Drainage Planning Conditions Supplementary Information

Subject: Land Off Elizabeth Street, Manchester

Ref: 080139

The Planning Permission Ref: 133125FO/2022
Variation Application number: 136813/JO/2023

hydro-int.com/patents

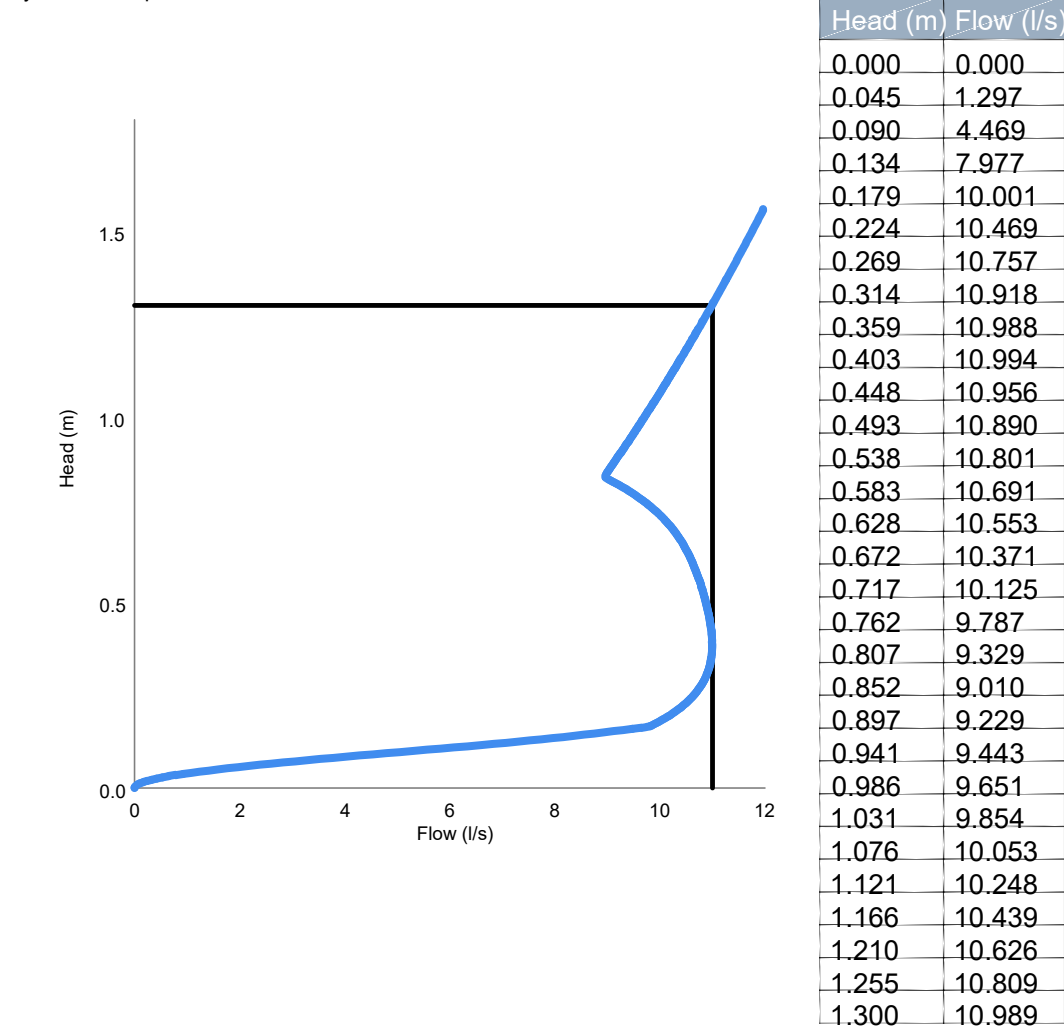
- Construction details of flow control and SuDS elements – Level of cover within the attenuation tank must be listed within the standard details; Typical drainage details sheet 3, 080139-CUR-XX-XX-DR-C-92522-P02. Details should be submitted for all SuDS components and reflect site specific details.

Attenuation Tank Sections have been updated, however they are generic as they refer to the manufacturer design. The contractor has proposed to use an SDS Geocellular tank and therefore SDS Details to be referred to.

Please refer to Appendix A for:
